Turbo HD DVR V3.4.70 build160708 Release Notes (2016-7-18)

Firmware Basic Information	Firmware Version:	V3.4.70 build160708
	SDK Version:	V5.2.1.5 build20160506
	Play Library (PlayCtrl.dll)	6.0.0.4
	player	7.3.0.74
	Web version	V4.0.1 build160622
	Client version	V2.04.06.19 build20160705

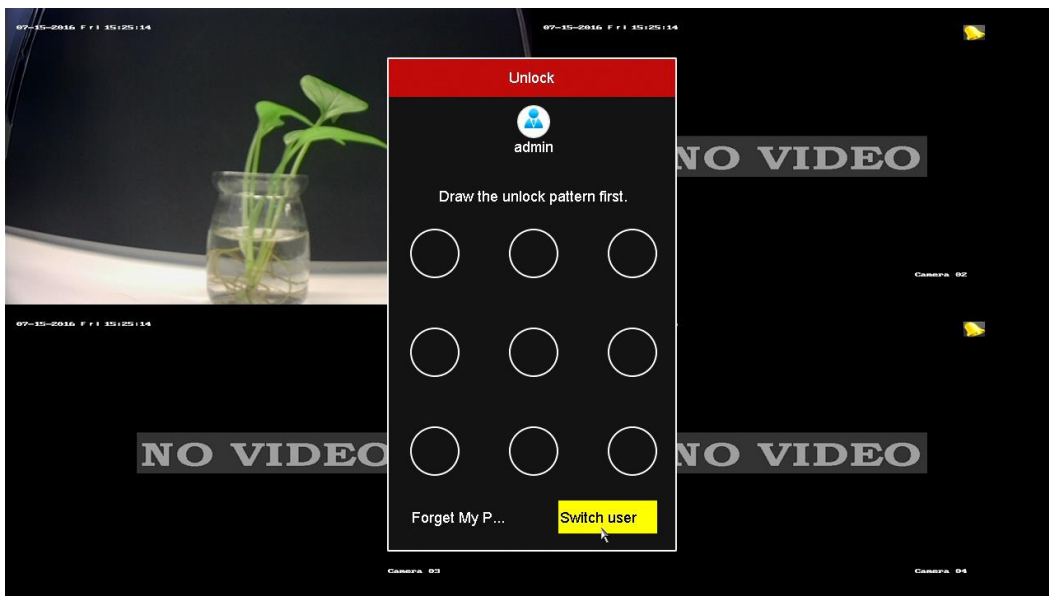
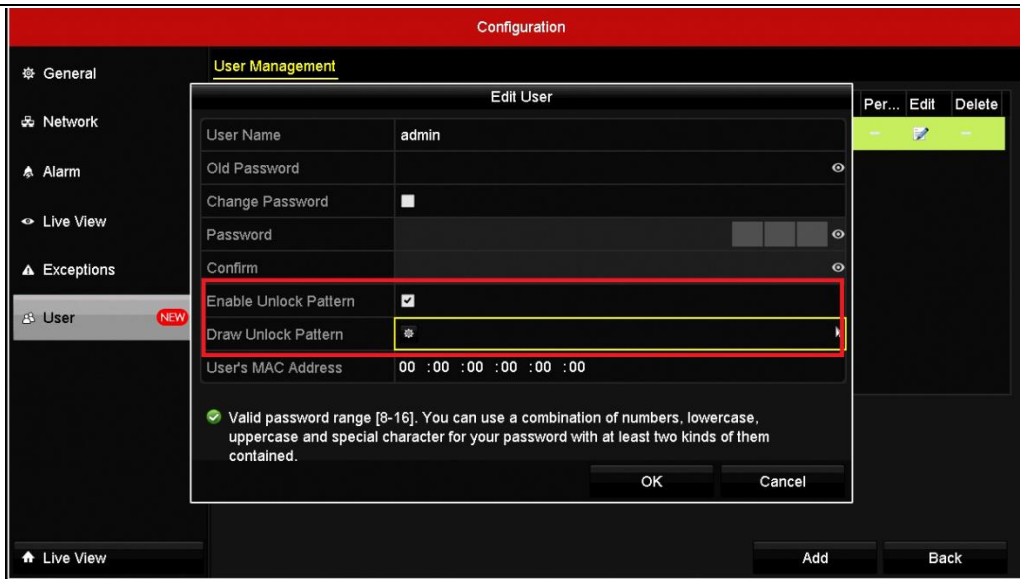
- i. **5 Hybrid:** TVI/AHD/CVI/CVBS/IP.
Completely self-adaptive, no channel binding restriction, no signal input configuration.
- ii. Newly support configuration of output bandwidth limitation: *Configuration->Network->More settings*. **It needs rebooting to achieve this function.**

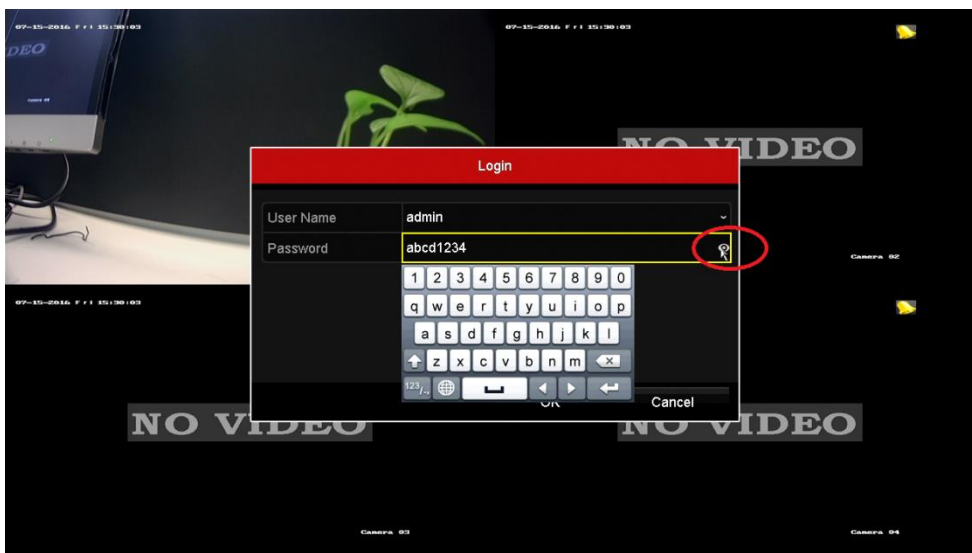
- iii. Newly support unlock pattern of admin account log in. Pattern can be set in *Configuration->User*, a pattern must connect at least 4 dots.

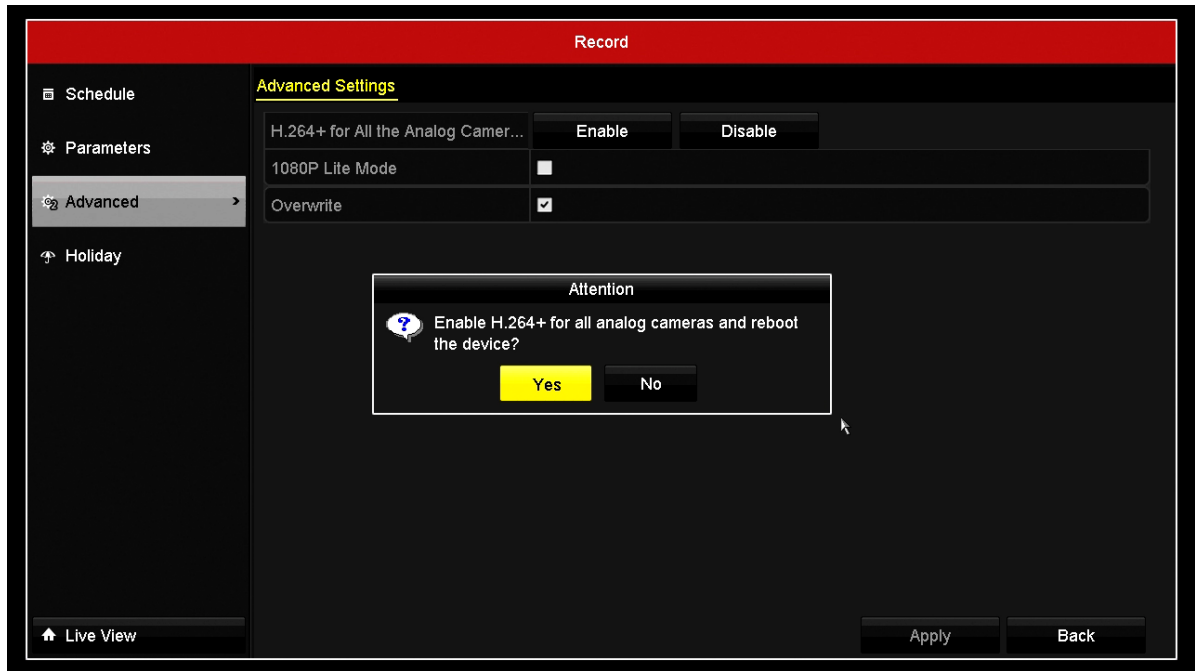
- iv. Newly support **plain text display of password function**.it will show the password when long press the left mouse button to click the icon on the right of input box.

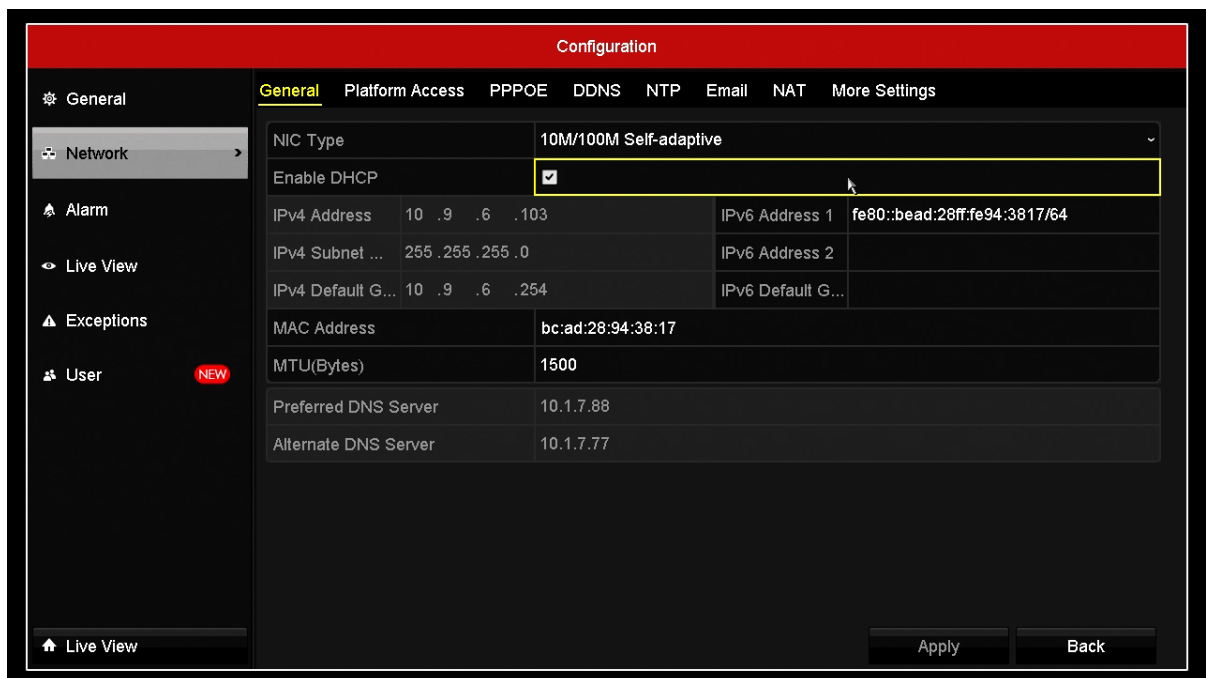
- v. Newly support one-key configuration of H.264+ for all analog channels: *Record->Advanced*. **Enable or Disable H.264+ needs rebooting the device.**

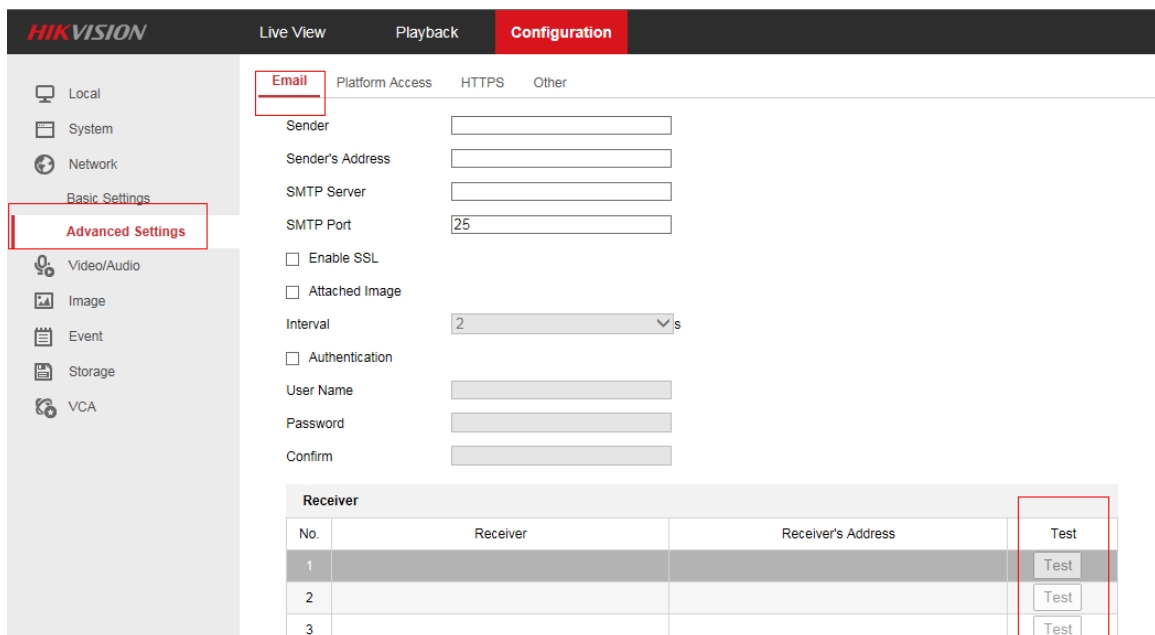
- vii. Newly support changing the signal input of F series TVI camera from 3MP to 2MP. Therefore F series TVI camera can be connected to HQHI-Fx/N series DVR.
- viii. Newly support configuration of **Camera Parameters Settings**, including Day to Night Sensitivity, Night to Day Sensitivity and IR Light Brightness. Only supported on **D7T/F7T/D0T-B** series.

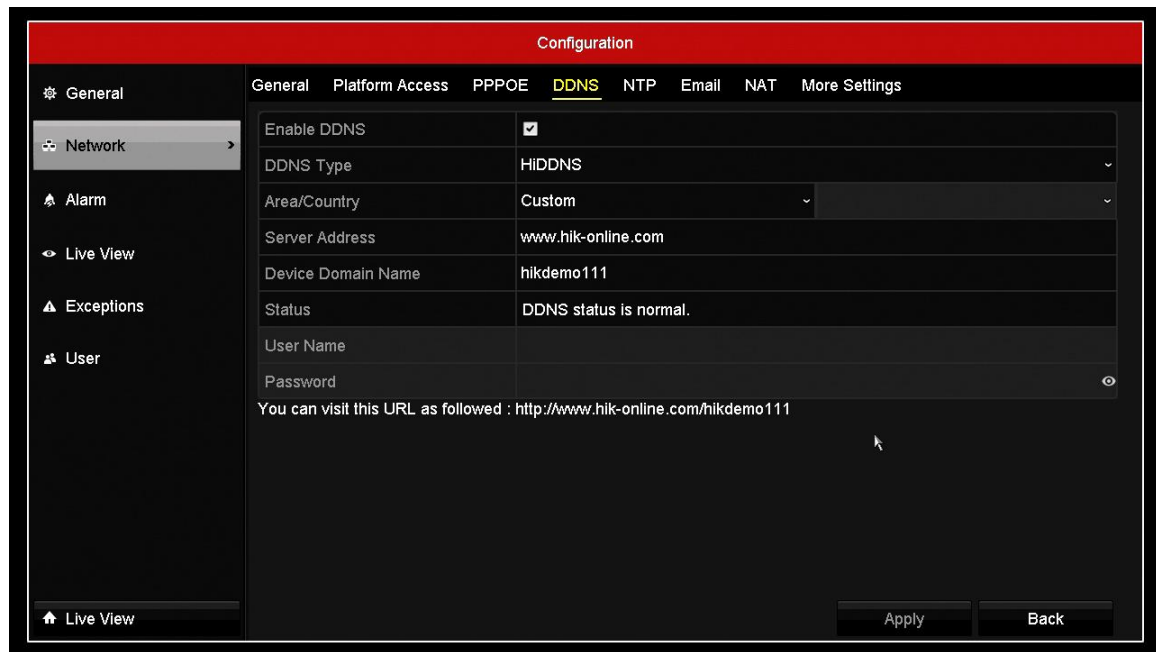
- ix. Newly support test function of Email on web browser.
